**SOMERSET COUNTY
NOTICE OF ADDENDUM**

**“Colonial Park Spray Park, Franklin Township, Somerset County, New Jersey,
Contract No.17008”**

ADDENDUM NO.1

UTILITY PLAN
 0 40 80
 SCALE: 1" = 40'

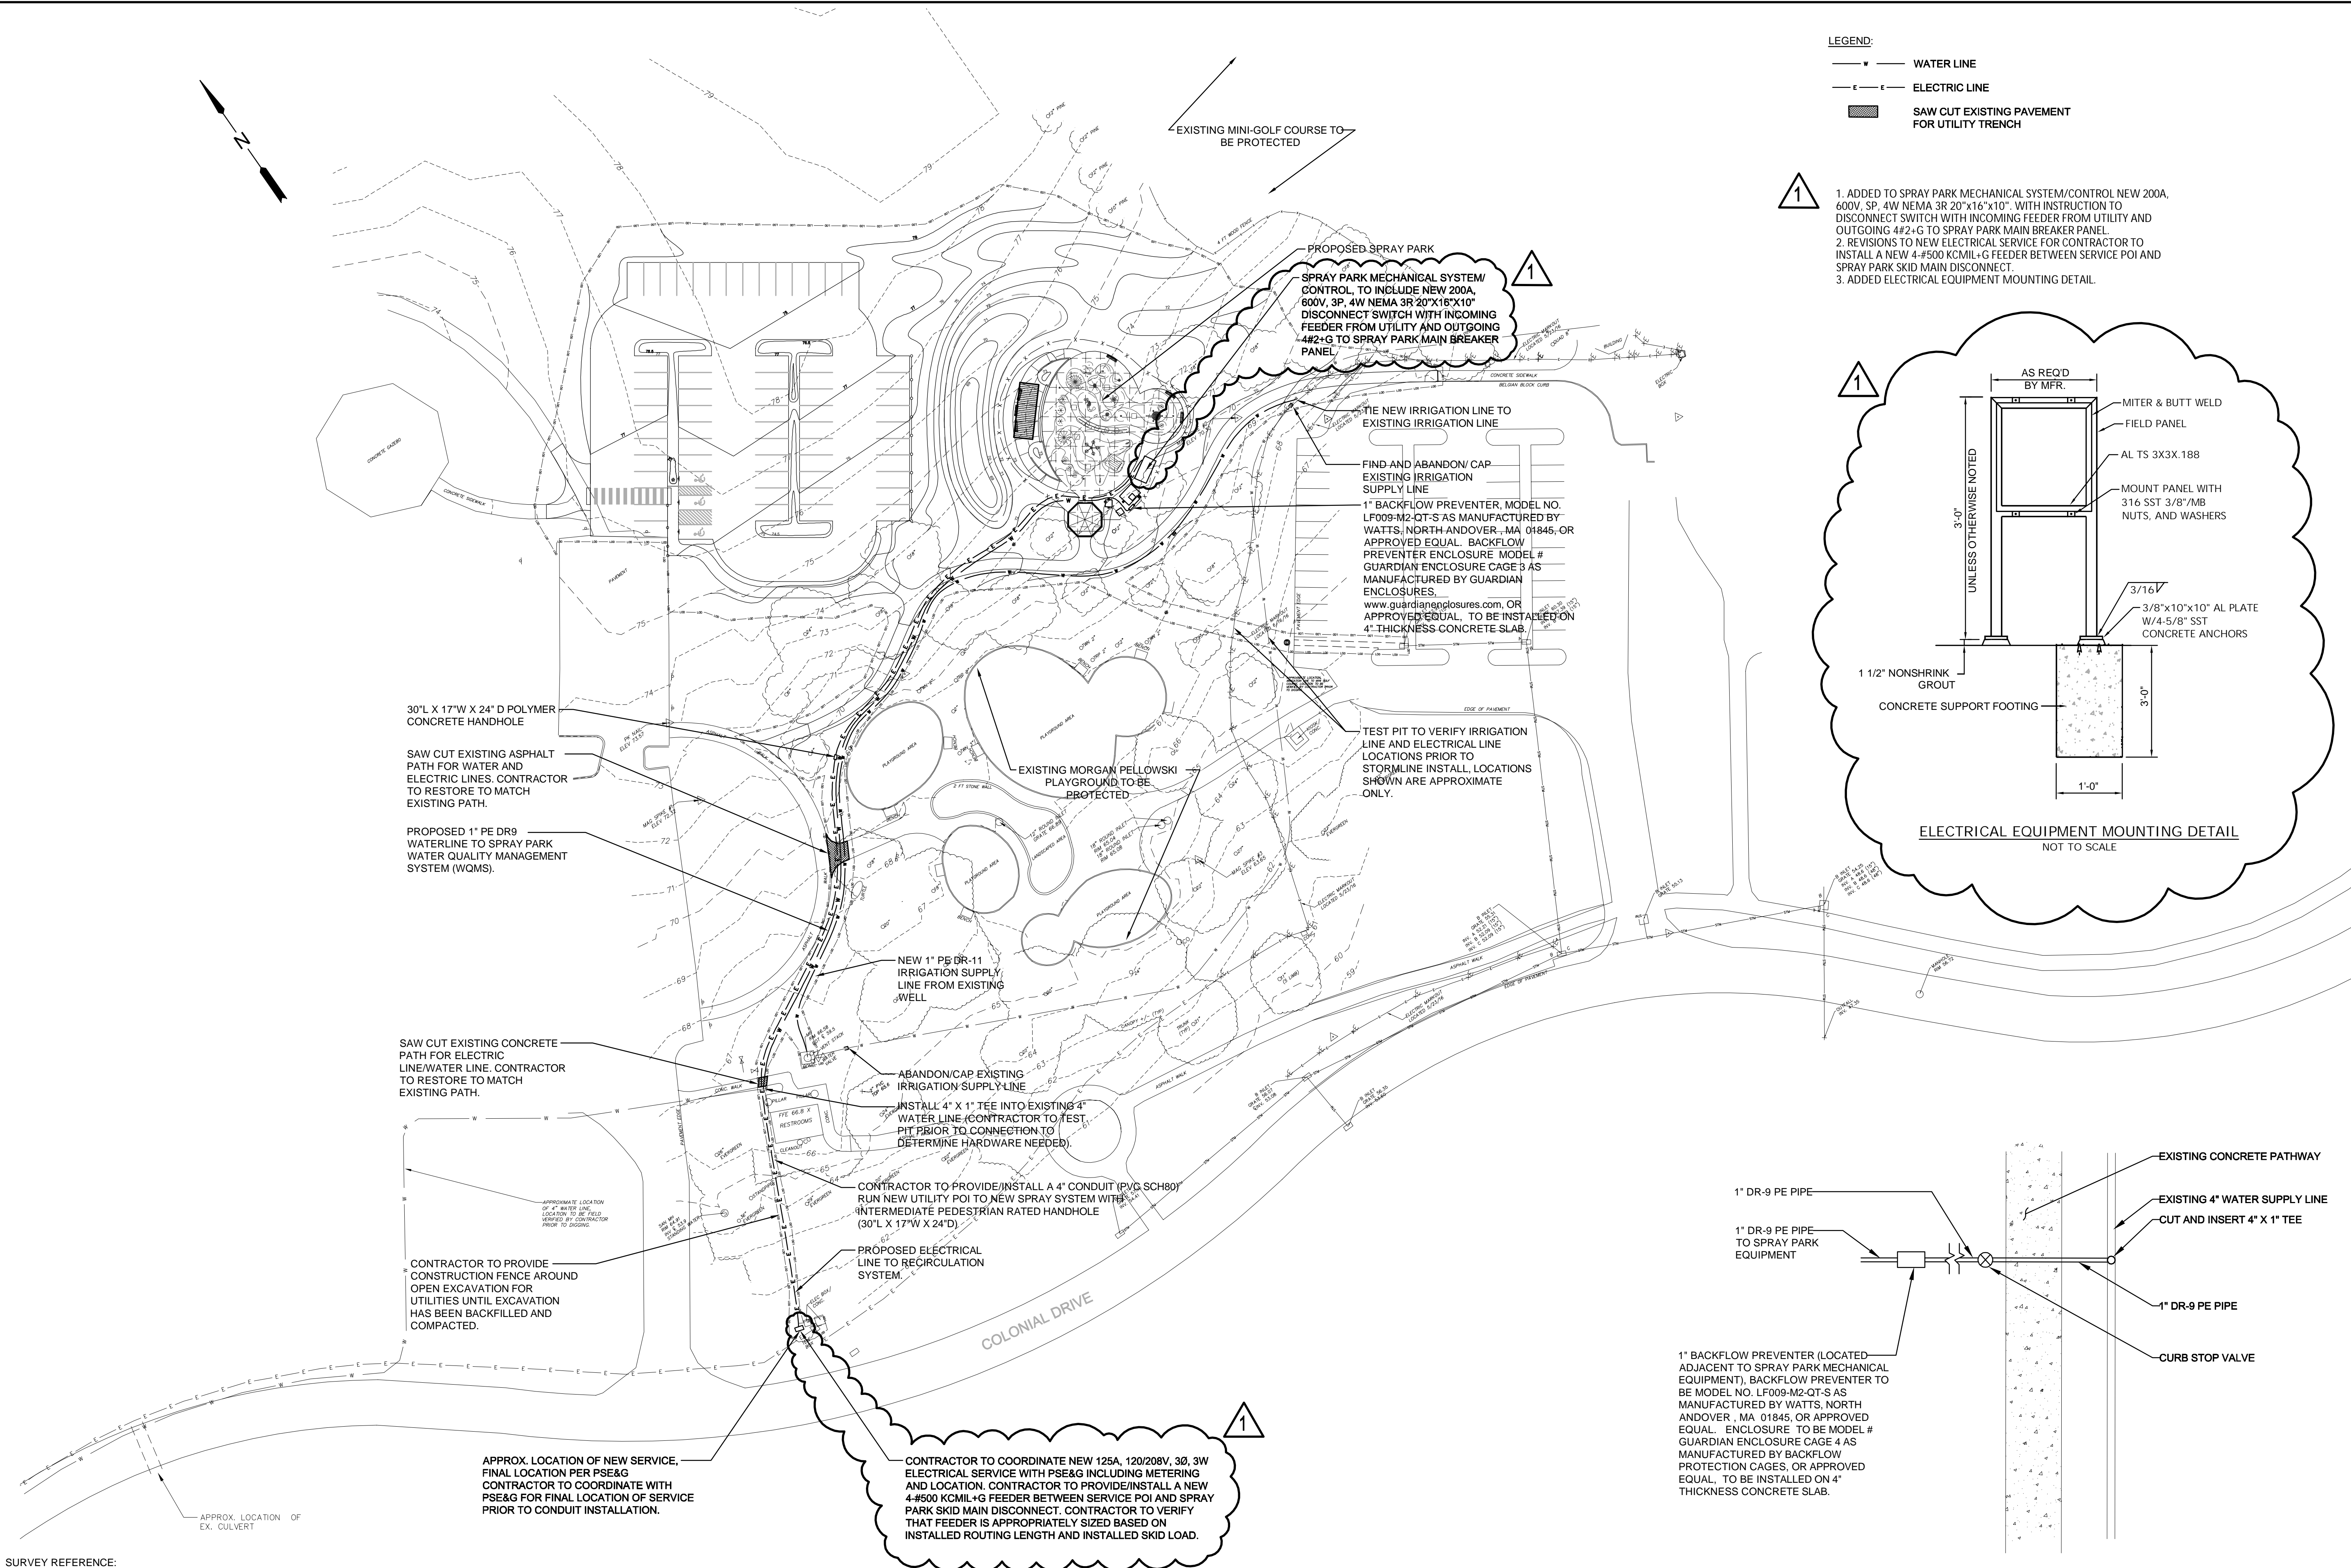
- Item 01: Contract Drawing Sheet S-5, Utility Plan is revised per the attached plan to include the Nema 3r disconnect switch. Additionally, the 3-#500 KCMIL+G feeder is revised to a 4-#500 KCMIL+G feeder from the electric service POI to the Spray Park skid main disconnect.
- Item 02: Contract Drawing Sheet L-1, Landscape Plan is revised per the attached plan to include the removal of “Stormwater Basin Plantings” from the plant schedule.

LANDSCAPE PLAN

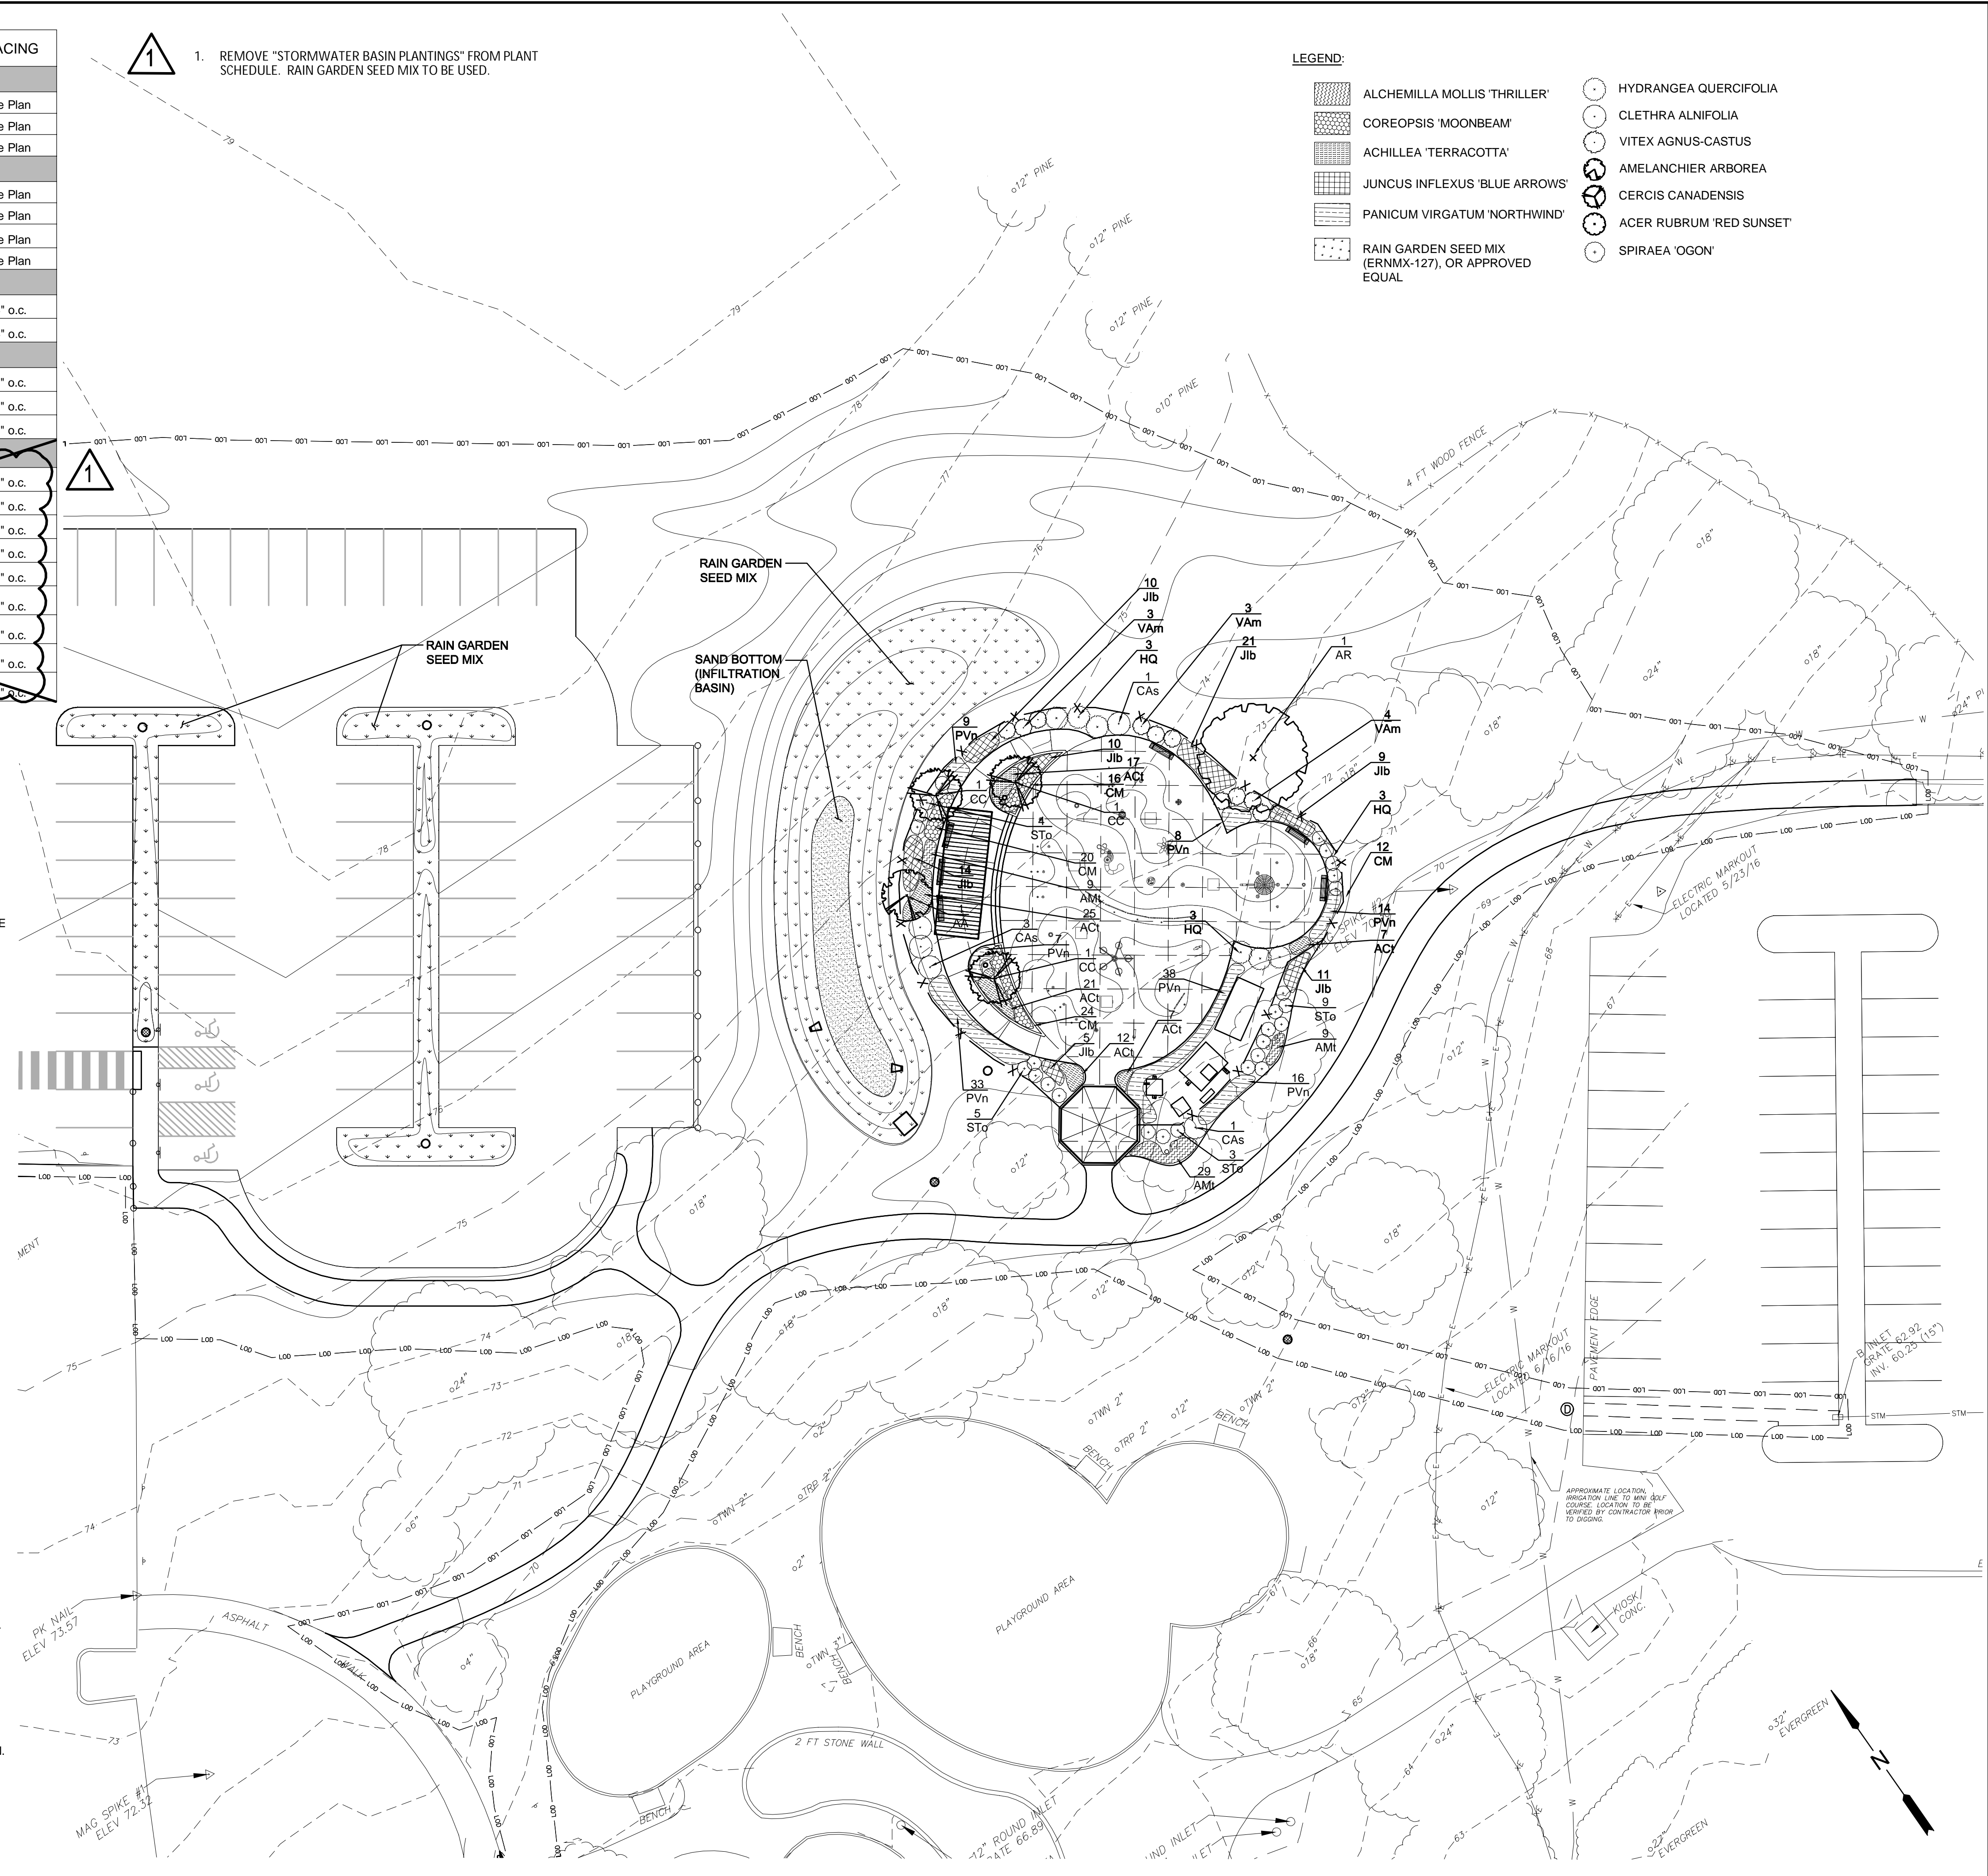
1. REMOVE "STORMWATER BASIN PLANTINGS" FROM PLANT SCHEDULE. RAIN GARDEN SEED MIX TO BE USED.
